Access Compliance Report

Public Rights-of-Way

Intersection ID: 10040201	Main Street: TYVOLA_RD	Cross Street: N/A	Location: SE
ADA ID: 8B8D65CE98EE	Ramp Type: BlendTrans2	Initial Pass/Fail: Fail	Overall Compliance: No
Severity Score: 1.25			
Codes/Mitigation Info/Possible Solution		Field Measurements/Component Compliance

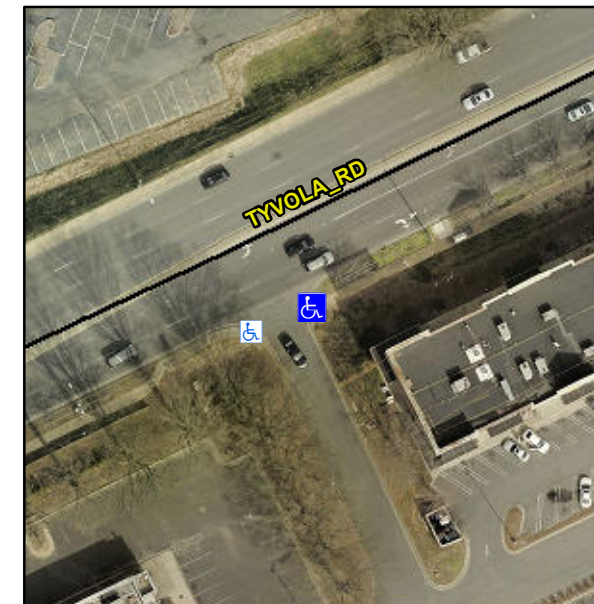
Not Found, R304.5.3

Compliance	Description	Data	Compliance	Description	Data
N/A	Ramp Length (in)	76.0	Yes	BlendTrans Slope (%)	4.7
Yes	Ramp Width (in)	53.5	No	BlendTrans XSlope (%)	2.3
N/A	Flare Type LT	N/A	N/A	Flare Type RT	N/A
N/A	Flare Slope LT (%)	N/A	N/A	Flare Slope RT (%)	N/A
N/A	Flare Traversable LT?	N/A	N/A	Flare Traversable RT?	N/A
N/A	Landing Length (in)	N/A	N/A	DWS Provided?	N/A
N/A	Landing Width (in)	N/A	N/A	DWS Contrast?	N/A
N/A	Landing Slope (%)	N/A	N/A	DWS Length (in)	N/A
N/A	Landing X Slope (%)	N/A	N/A	DWS Full Width?	N/A
N/A	Landing Curb? (Y/N)	N/A	N/A	DWS Offset (in)	N/A
N/A	Shared Landing?	N/A			
N/A	Gutter Ponding?	N/A	N/A	Gutter Slope (%)	N/A
N/A	Gutter Lip Ht (in)	N/A	N/A	Gutter X Slope (%)	N/A
N/A	Painted X Walk1?	No	N/A	Painted X Walk2?	N/A
	X Walk 1 Direction	To SW		X Walk 2 Direction	N/A
	X Walk 1 Width (in)	N/A		X Walk 2 Width (in)	N/A
	X Walk 1 Slope (%)	2.5		X Walk 2 Slope (%)	N/A
	X Walk 1 X Slope (%)	0.7		X Walk 2 X Slope (%)	N/A

N/A	Ramp inside XWalk1?	N/A	N/A	Ramp inside XWalk2?	N/A
	Road Slope (%)	0.7		Clear Space?	N/A
	Road X Slope (%)	2.5	N/A	Clear Space to XWalk (in)	N/A
N/A	Any Obstructions?	N/A	N/A	Storm Grate/Utility Hazard?	N/A
	Obstruction Type			Storm Grate/Utility Type	
		N/A			N/A
			Yes	Surface Condition? (G/P)	Good
			No	Curb Slope (%)	14.9

Remove & Replace Curb Ramp With Two New Directional Ramps or Equivalent.
